Project: **La Jara Dental Clinic – Addition & Remodel** Project No.: 2614

Addendum No.: **02**

Date: **09/14/2026**

A-101

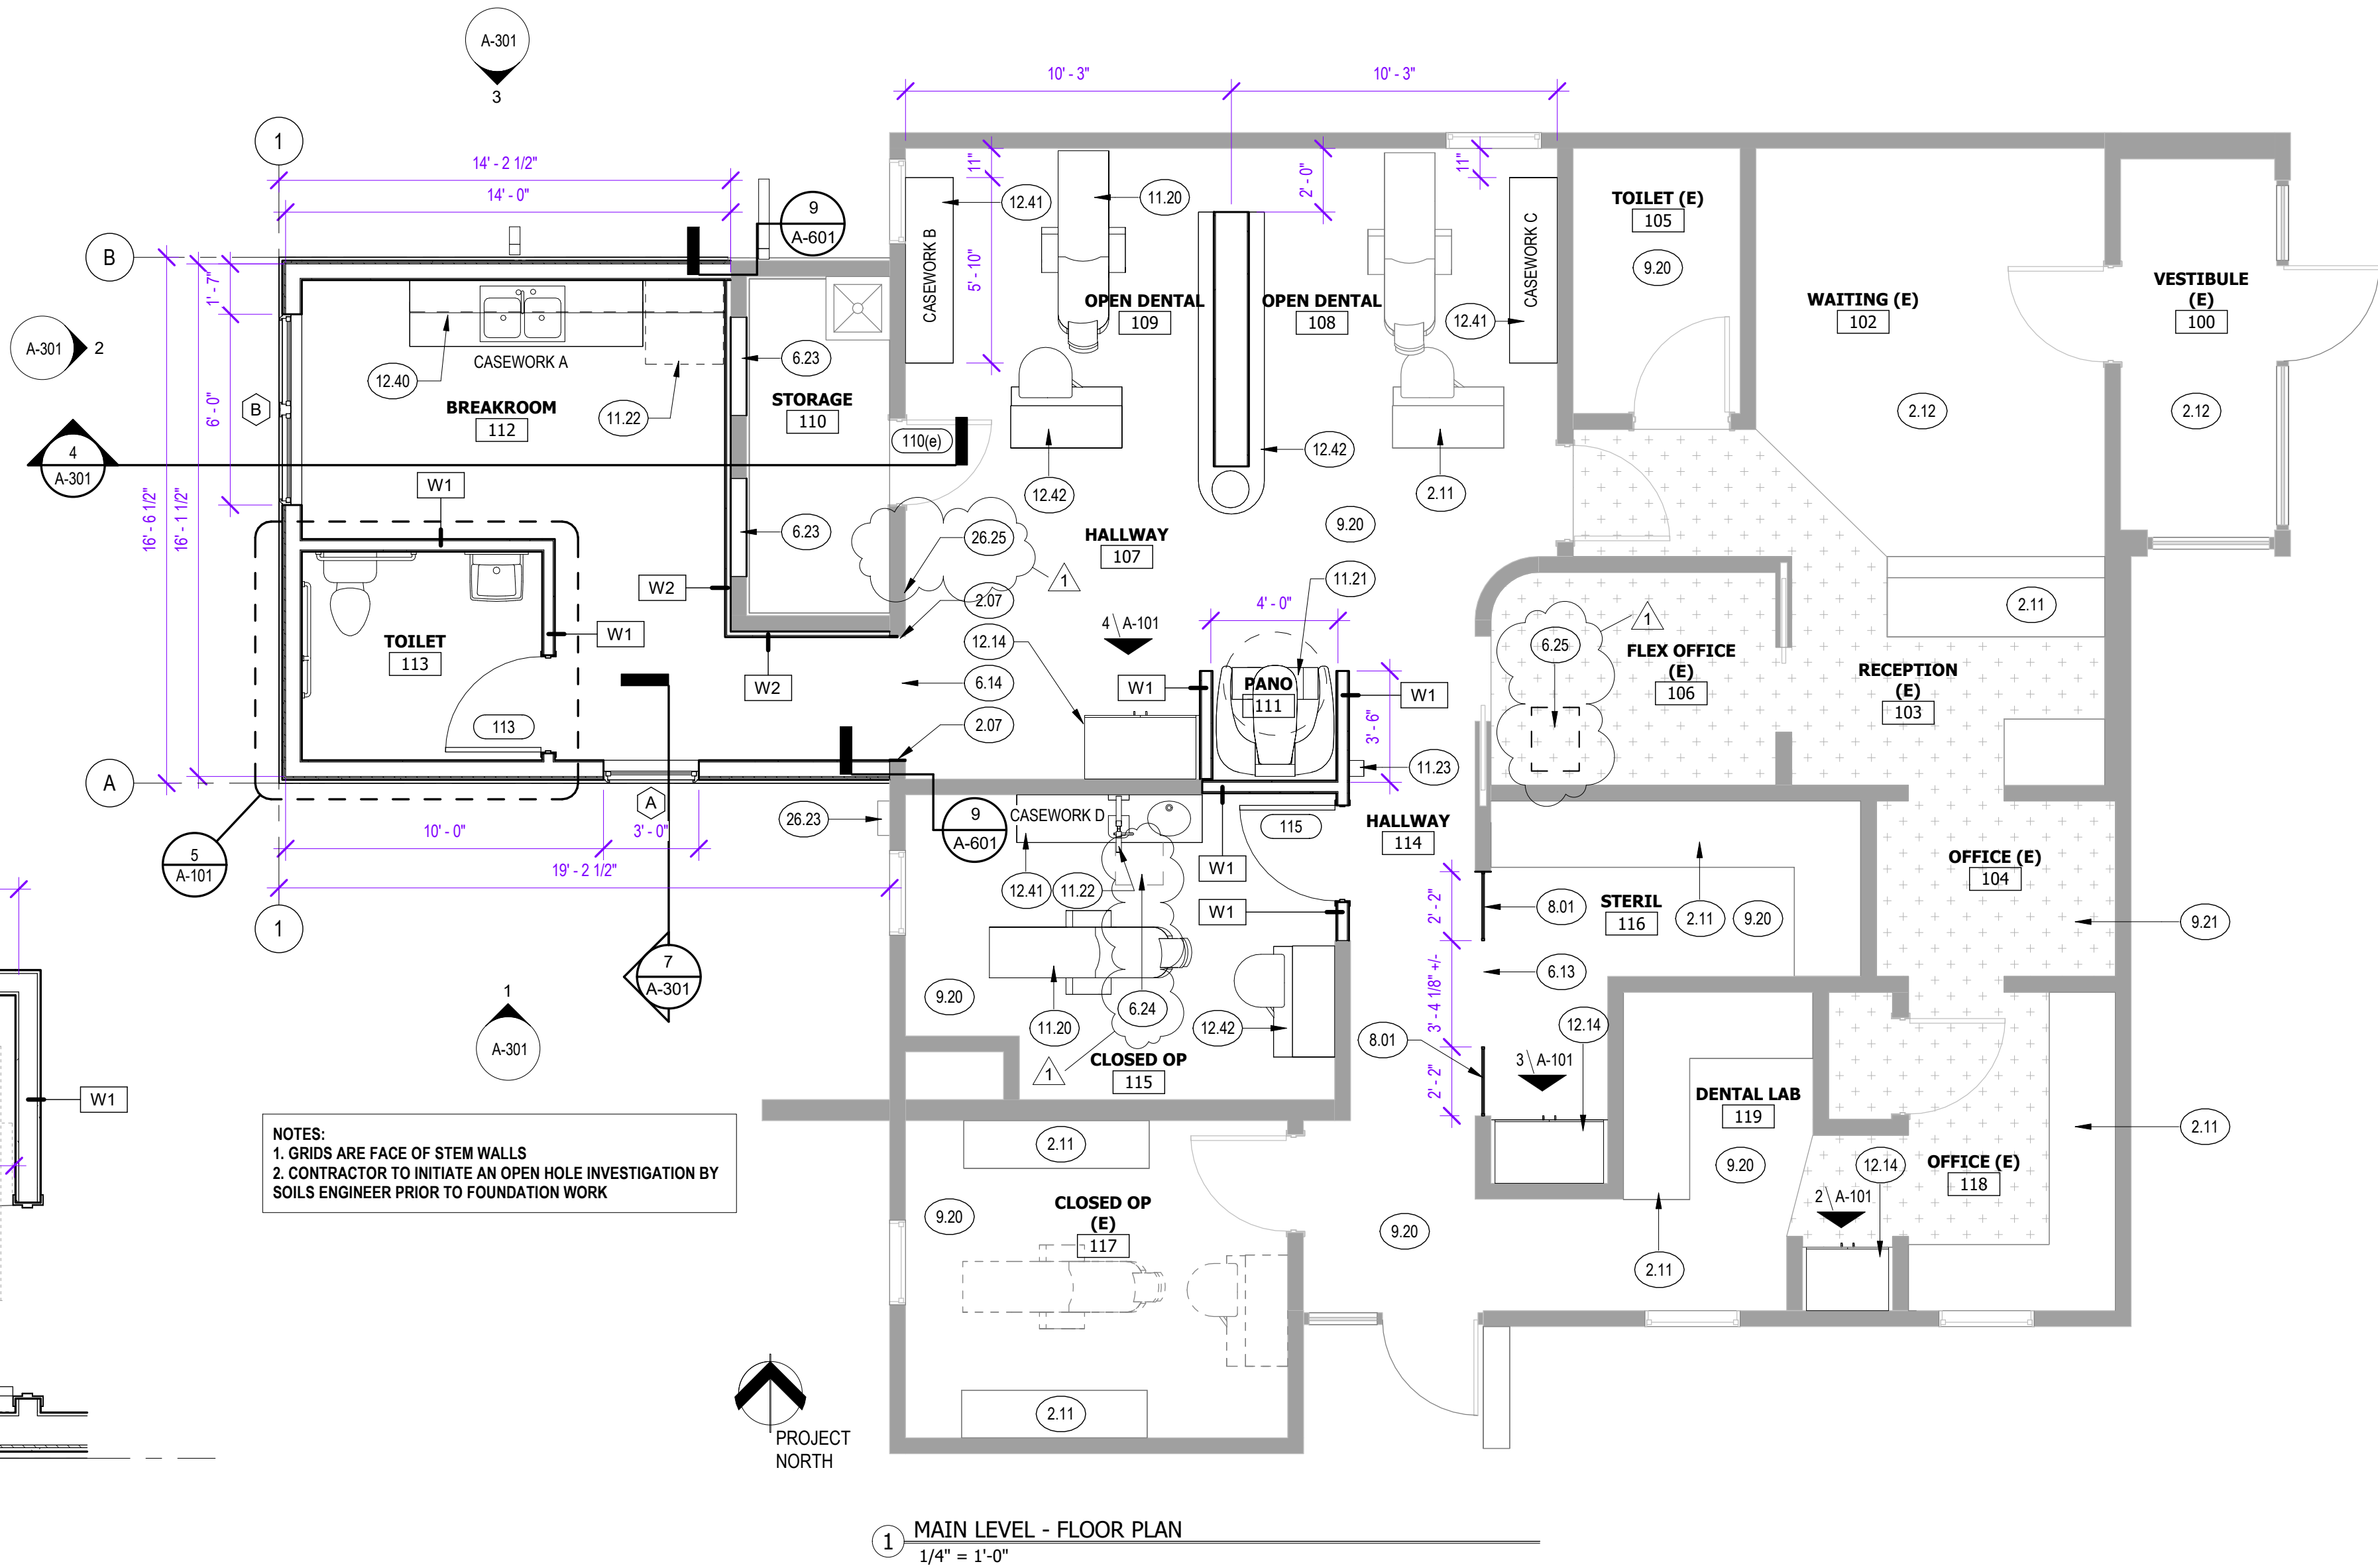
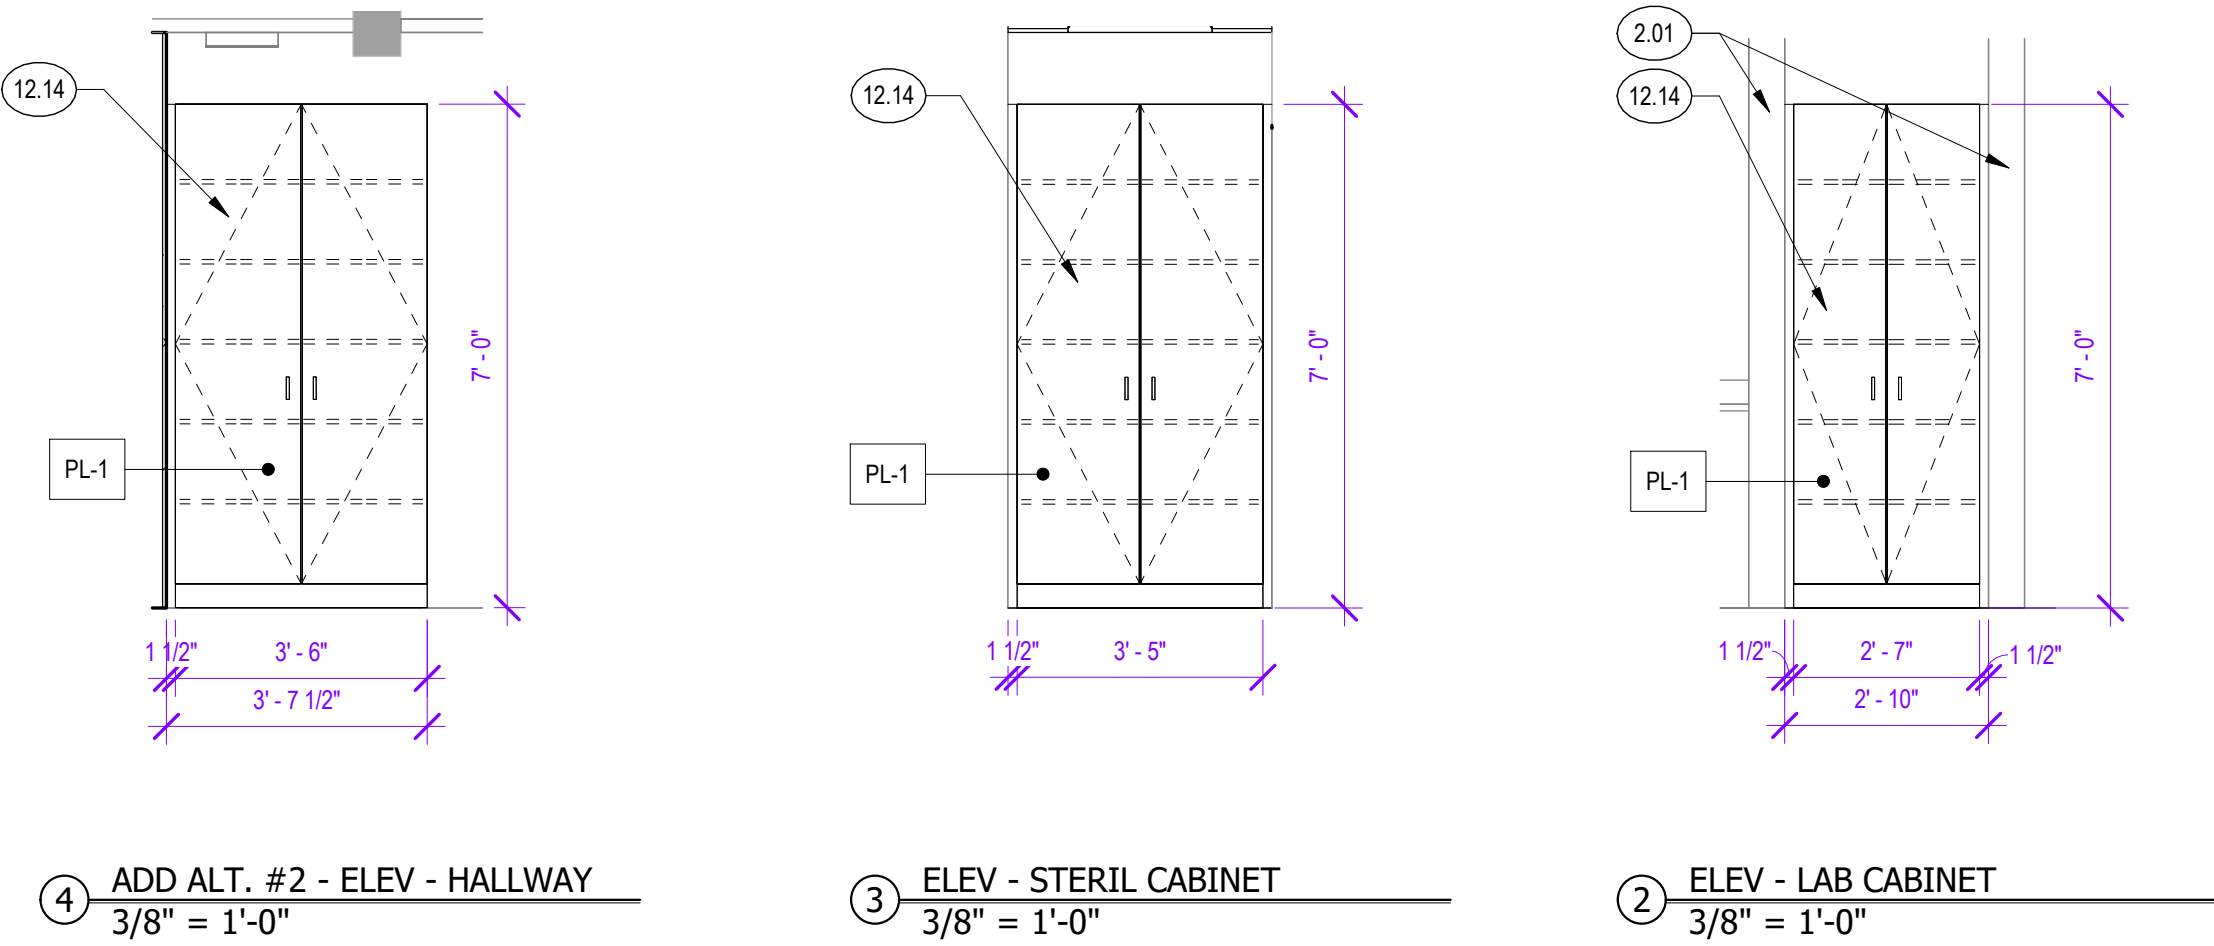
- a. T-001: Include \$5,000 allowance noted above. This requirement has been added to cover sheet.
- b. AD-101 & A-101 & M-111: Scope added to demo work on West wall. Contractor is responsible for removing baseboard heater and wire mold along this wall. If wire mold is in use, reroute wire and new wire mold up over new hallway opening.
- c. AD101 & A-101: Existing access to crawl space needs to move. Remove existing panel and infill per A-101. New access will be in office 106. Confirm exact location with owner on site. Flooring and sub flooring to be demoed for new access. Existing access panel to be reused.
- d. A-101: Carpet tile specification added.
- e. PD-111 & P-111: Remove and relocate existing cleanout as noted.
- f. ED-121 & E-121 & E-601: New electric service needed. Demo existing. Contractor to re-feed existing panel A from new service.

Sheet AD-101, Demolition Keynote D24, identifies two existing items to be removed and reused. Sheet A-101, Keynote 12.42, shows their proposed relocated positions. Both items appear to have the same footprint on the demolition plan, but one is shown with a reversed footprint on the proposed plan. Please clarify whether the existing item can be reused as shown or whether modification or replacement is required. **These 12'o'clock units are all identical – no modifications needed. (2) to remain in the open area and (1) moves into the Closed Op 115, positioned on East wall facing West.**

Sheet A-101, Interior Finish General Note 1, requires flooring to extend from partition to partition. Please confirm whether existing casework designated to remain in Open Dental 108 and Closed Op 117 must be removed and reinstalled to accommodate the new

22.01 ACCESSIBLE TOILET; SEE PLUMBING
22.02 ACCESSIBLE SINK; SEE PLUMBING
26.23 ELECTRICAL BOX TO REMAIN; SEE ELEC.
26.25 IF DEMOED WIRE MOLD WAS IN USE, REROUTE WIRE AND NEW WIRE MOLD UP AND OVER HALLWAY OPENING

flooring. Casework in Dental Op 108 (Casework C on plans) will move into Closed Op 115. Flooring in closed Op 117 can terminate at casework.
